TORQUE ARM ASSEMBLY

STAR GUY BRACKET FOR 456  
JSI 9/20/2004  
REV 1 PAGE 1

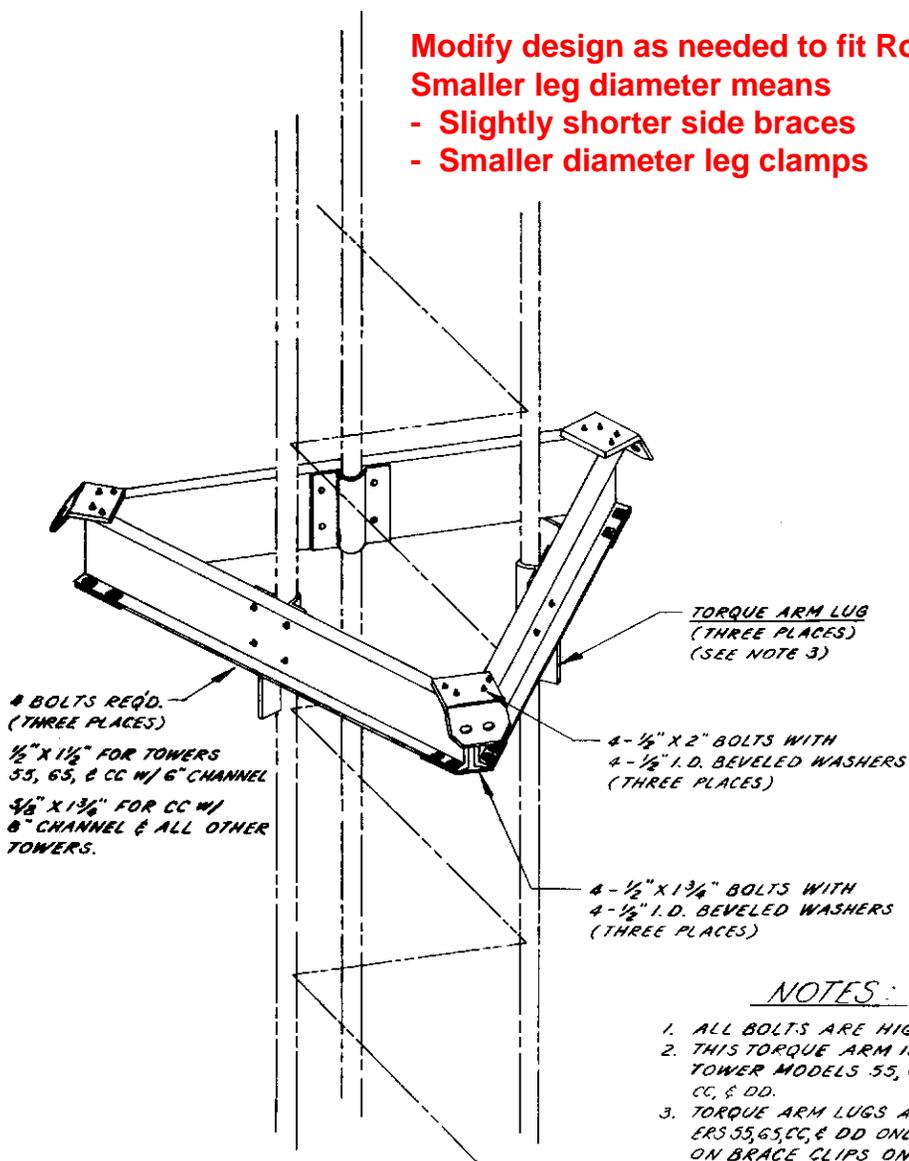
Modify design as needed to fit Rohn 45G  
 Smaller leg diameter means  
 - Slightly shorter side braces  
 - Smaller diameter leg clamps
